Recall Service Bulletin

DATE: 11-02-16

APPLIES TO: This Recall service bulletin applies to motorhome chassis, model year 2017, K2 and K3 models built between March 24, 2016 and August 31, 2016.

NHTSA/TC Id: 16V-776

FIG. 3-2

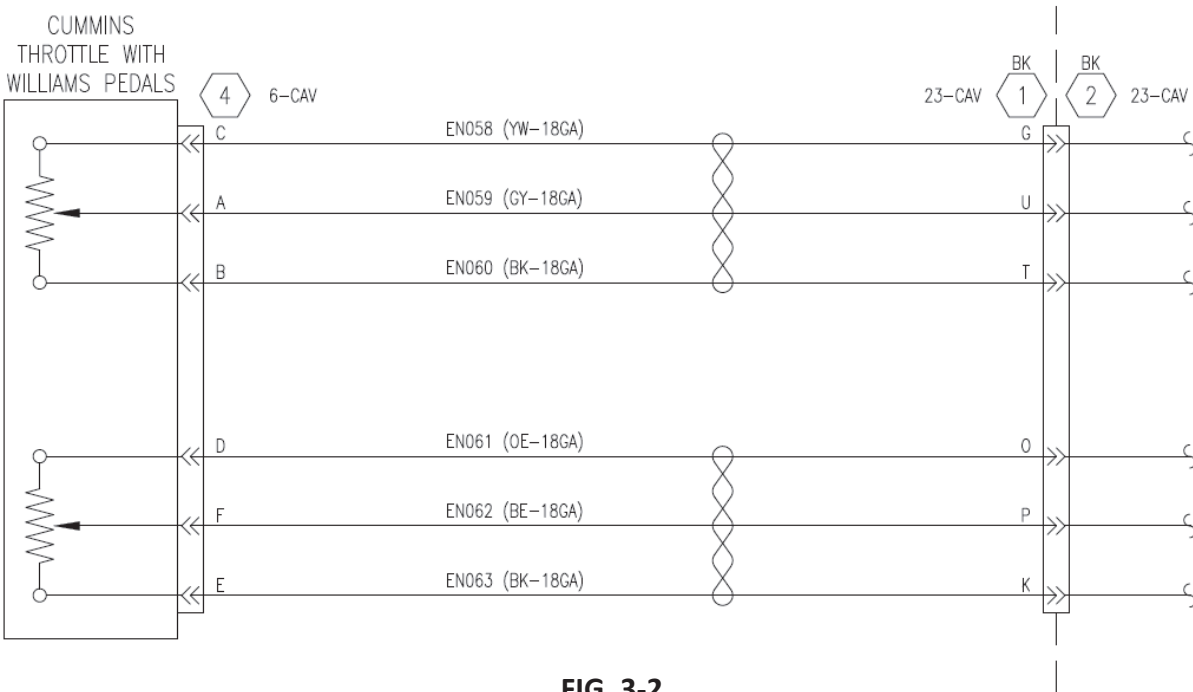
CONDITION: Certain wires in the throttle circuit were not twisted which could result in a throttle setting above or below the commanded throttle setting/input.

1. Identify and disconnect throttle pedal connector, Item ④ in FIG. 3-2, from throttle assembly. Pull back loom 12 inches over wiring terminated into throttle pedal connector. Verify wiring consists of 6 discreet wires (untwisted) then go to step 2. If wiring consists of 2 twisted triplets (refer to FIG. 3-2), replace loom over wiring and reconnect throttle pedal connector, Item ④. No further action is required.

2. Pull back existing throttle pedal connector and stow/tape it back onto existing harness.
3. Connect new throttle pedal connector, Item ④, of new 3995-GG5-001 overlay harness into throttle assembly. Refer to FIG. 3-2.

5. Locate and disconnect main chassis harness interconnect, Item ①, from forward electrical compartment disconnect. Refer to FIG. 3-2
6. Using Deutsch contact removal tool, remove circuits from disconnected Item ①, cavities O, P, K, G, U, and T. Refer to FIG. 3-1.

CORRECTION: Adding an overlay harness with properly twisted wiring.

- Cut off contacts from removed circuits, individually heat shrink, and pull/tape back onto existing harness.
- Insert new circuits from new overlay harness into existing main chassis harness interconnect connector Item 1. Refer to FIG. 3-1. Each wire is tagged with a label depicting which cavity it belongs in. Refer to FIG. 3-2. Note that the wiring/pin out does not change.

9. Re-connect main chassis harness interconnect connector, Item , to firewall disconnect. Refer to FIG. 3-2.
10. Assure new overlay harness is secured to existing harness as required throughout its entire run. Tape back any extra length as required.
11. Using Cummins® INSITE™, verify that no fault codes are generated at key-up. Also verify that appropriate values are seen in regards to throttle pedal position.

FIG. 6-1

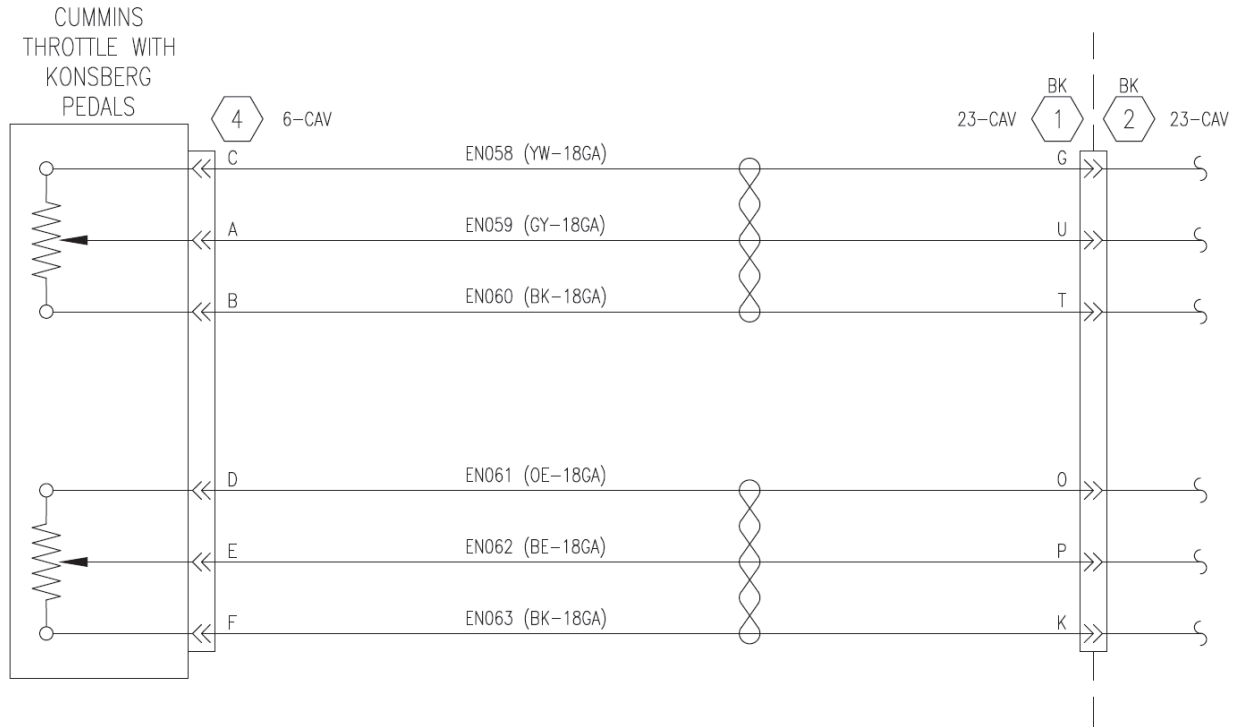
8. Insert new circuits from new overlay harness into existing main chassis harness interconnect connector Item **1** . Refer to FIG. 5-1. Each wire is tagged with a label depicting which cavity it belongs in. Refer to FIG. 6-1. Note that the wiring/pin out does not change.

9. Re-connect main chassis harness interconnect connector, Item **1** , to firewall disconnect. Refer to FIG. 6-1.
10. Assure new overlay harness is secured to existing harness as required throughout its entire run. Tape back any extra length as required.
11. Using Cummins® INSITE™, verify that no fault codes are generated at key-up. Also verify that appropriate values are seen in regards to throttle pedal position.

FIG. 8-1

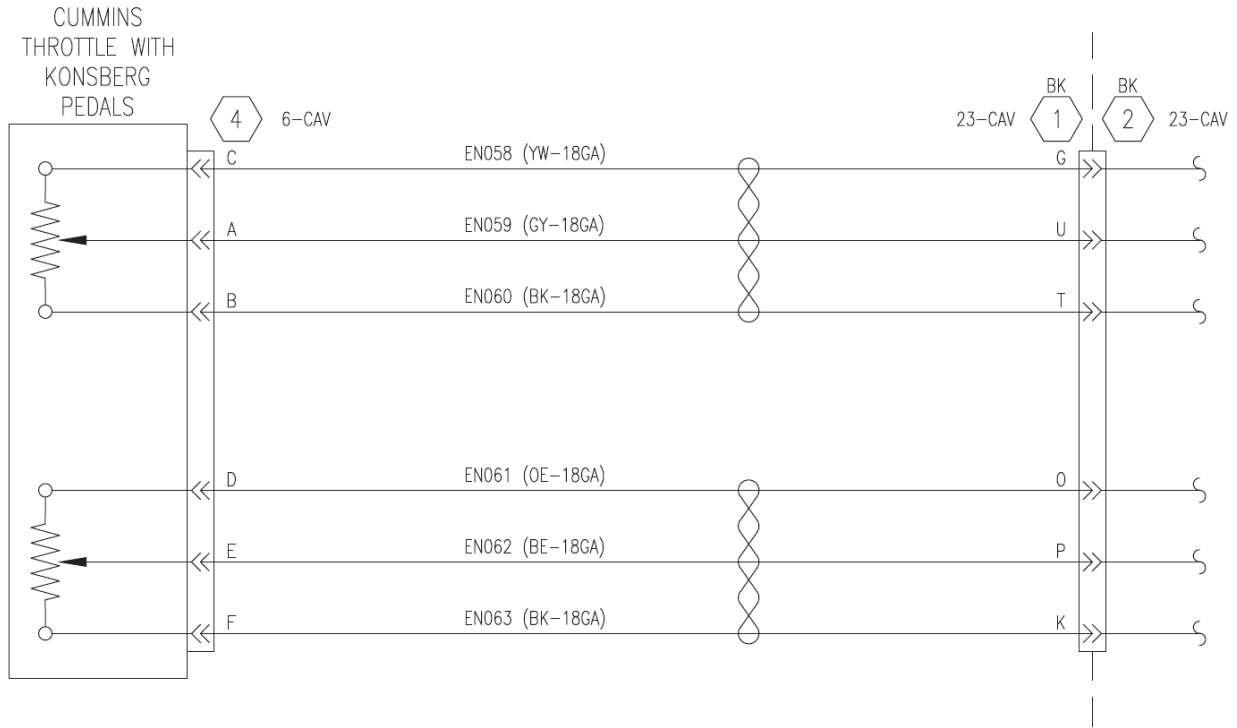
1. Identify and disconnect throttle pedal connector, Item **④** in FIG. 8-1, from throttle assembly. Pull back loom 12 inches over wiring terminated into throttle pedal connector. Verify wiring consists of 6 discreet wires (untwisted) then go to step 2. If wiring consists of 2 twisted triplets (refer to FIG. 8-1), replace loom over wiring and reconnect throttle pedal connector, Item **④**. No further action is required.

2. Pull back existing throttle pedal connector and stow/tape it back onto existing harness.
3. Connect new throttle pedal connector, Item **④**, of new 3995-GG5-002 overlay harness into throttle assembly. Refer to FIG. 8-1.

5. Locate and disconnect main chassis harness interconnect, Item **①**, from forward electrical compartment disconnect. Refer to FIG. 8-1.
6. Using Deutsch contact removal tool, remove circuits from disconnected Item **①** cavities O, P, K, G, U, and T. Refer to FIG. 7-1.

- Insert new circuits from new overlay harness into existing main chassis harness interconnect connector Item **1** . Refer to FIG. 7-1. Each wire is tagged with a label depicting which cavity it belongs in. Refer to FIG. 8-1. Note that the wiring/pin out does not change.

- Re-connect main chassis harness interconnect connector, Item **1** , to forward electrical compartment disconnect. Refer to FIG. 8-1.
- Assure new overlay harness is secured to existing harness as required throughout its entire run. Tape back any extra length as required.
- Using Cummins® INSITE™, verify that no fault codes are generated at key-up. Also verify that appropriate values are seen in regards to throttle pedal position.
